Campaign Directive
Slider Door Catches for FMVSS 206 UPS

F9: 9F9B79 NHTSA ID: 11V-6

Situation: Certain work trucks do not comply with FMVSS 206, S4.2.1, which requires each sliding door system to be equipped with either a primary door latch system or a door latch system with a fully latched position and a door closer warning system.

Corrective Action Summary for Standard Catches: Replace forward door catches with 2-position catches.

Discard original latch and fasteners

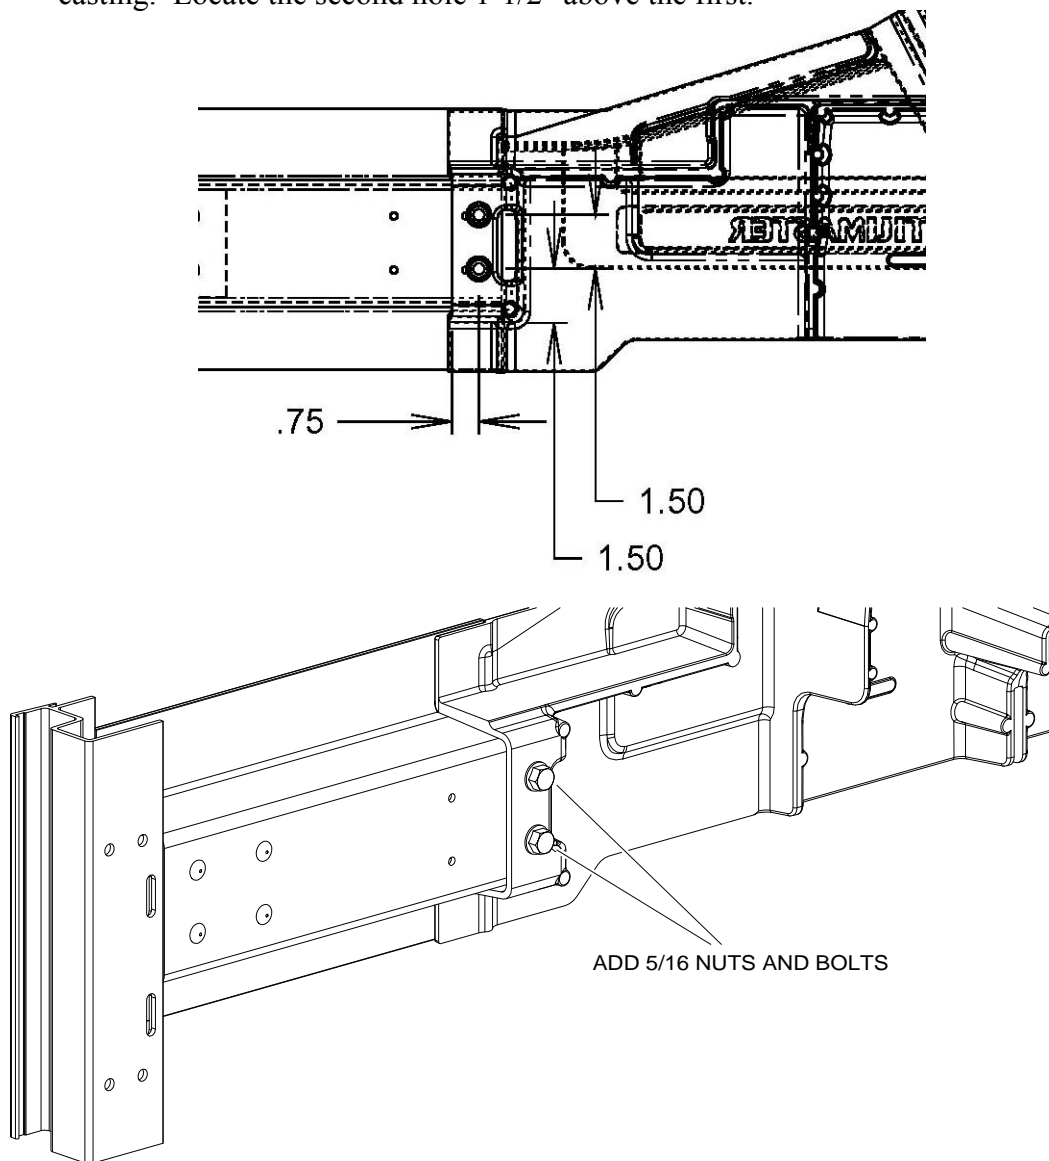
4. Remove the Torx-head set screw.
5. Remove the steel door catch and discard.

5/16" fasteners at the quarter panel casting

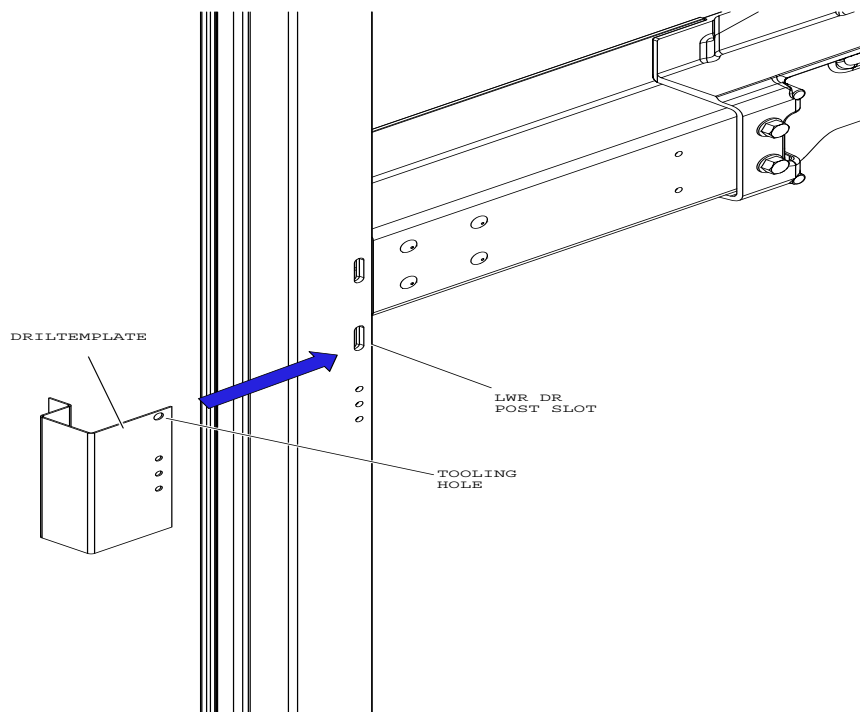
Set drill stop no deeper than 5/16" to avoid the wires inside the casting when drilling through quarter post casting.

- Set the drill stop to 5/16" and drill (2) 5/16" holes in the quarter post casting. Locate the bottom hole 3/4" from the rear edge and 1-1/2" from the bottom of the casting. Locate the second hole 1-1/2" above the first.

- Torque the bolts to 10–15 ft•lbs.

Align drill template with slot in lower door post

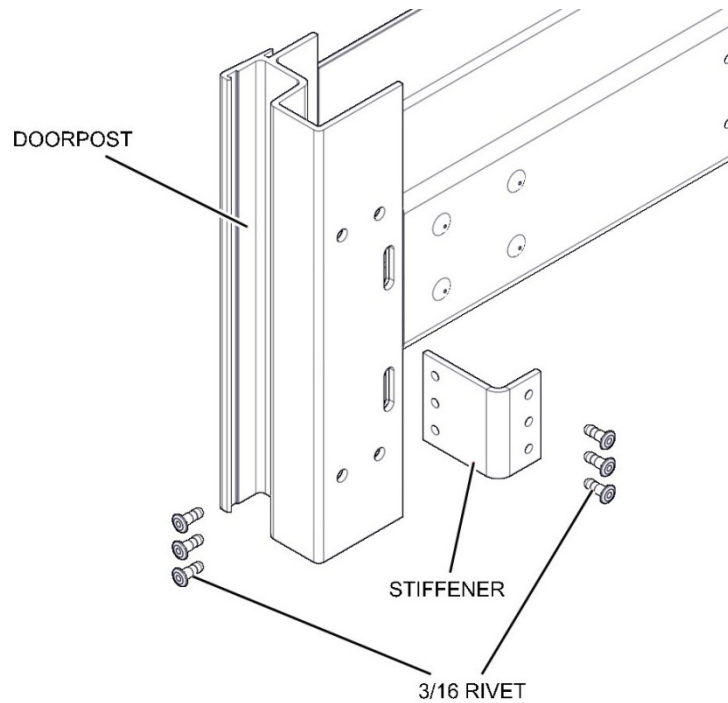
9. Align the (left-hand or right-hand) drill template with the lower slot in the forward doorpost with a pin or bolt.

Quarter post rotation stiffener installed

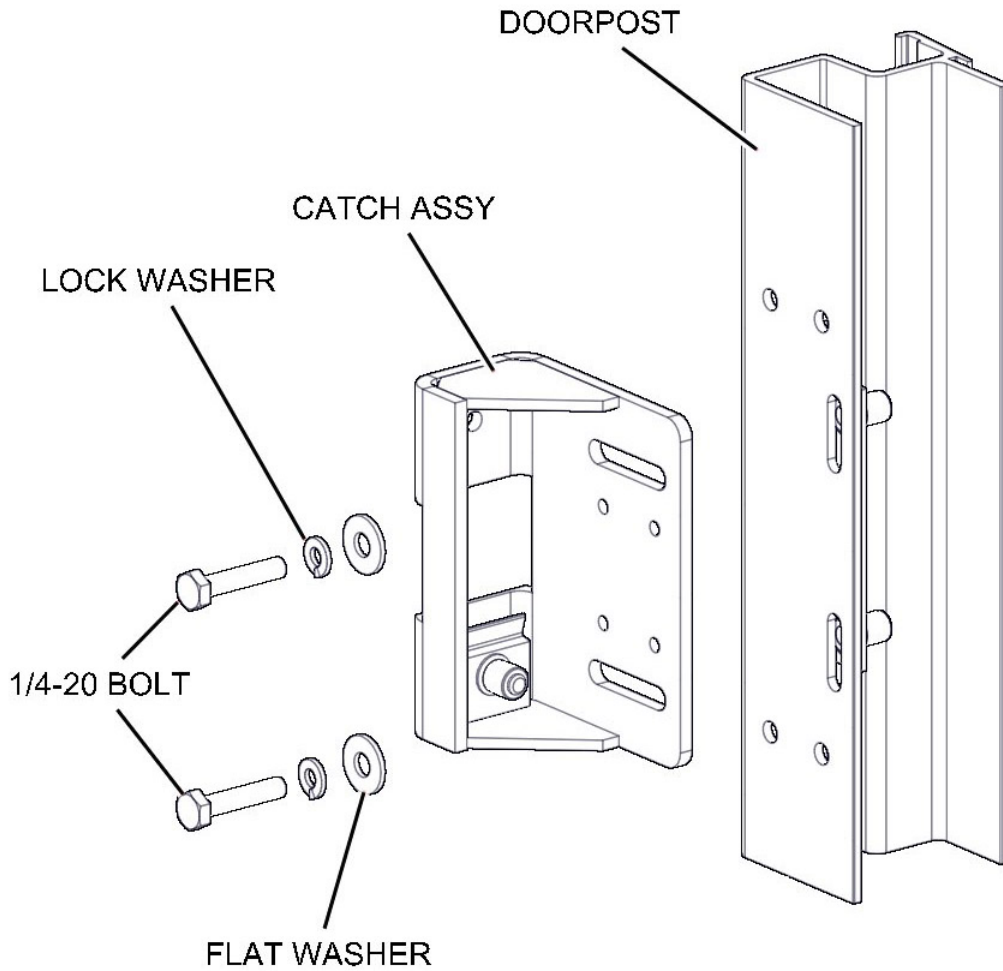
10. Use the template as a guide and mark the (6) holes.
11. Drill (6) 3/16" holes in the doorpost.
12. Secure the stiffener with (6) blind rivets.

2-position door catch configuration

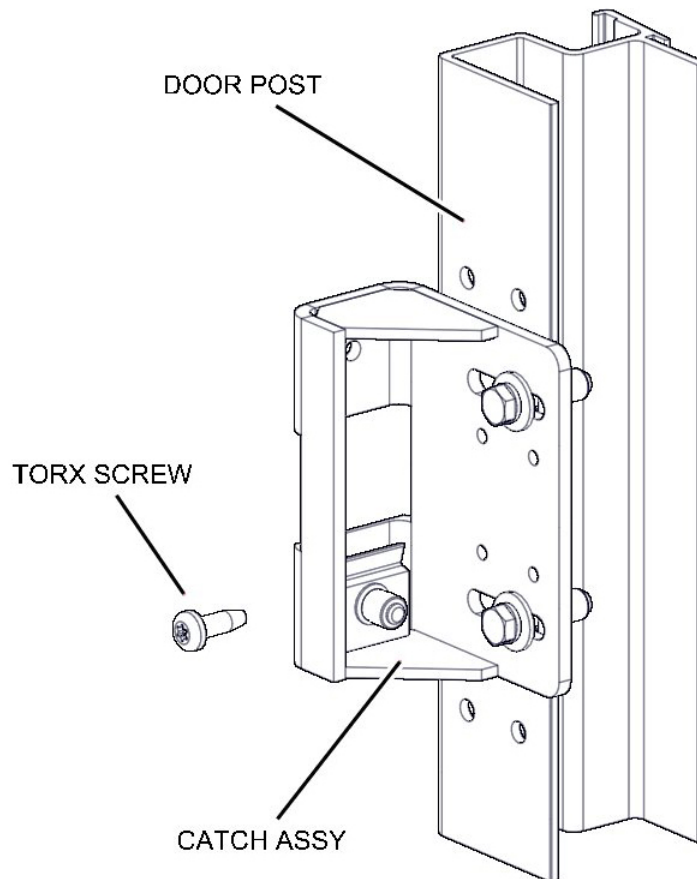
Do NOT use thread lock on the door catch fasteners.

14. Secure the catch (with the silver pin down) to the doorpost with flat washers, lock washers, and 1/4-20 bolts.

Silver pin indicates bottom of catch
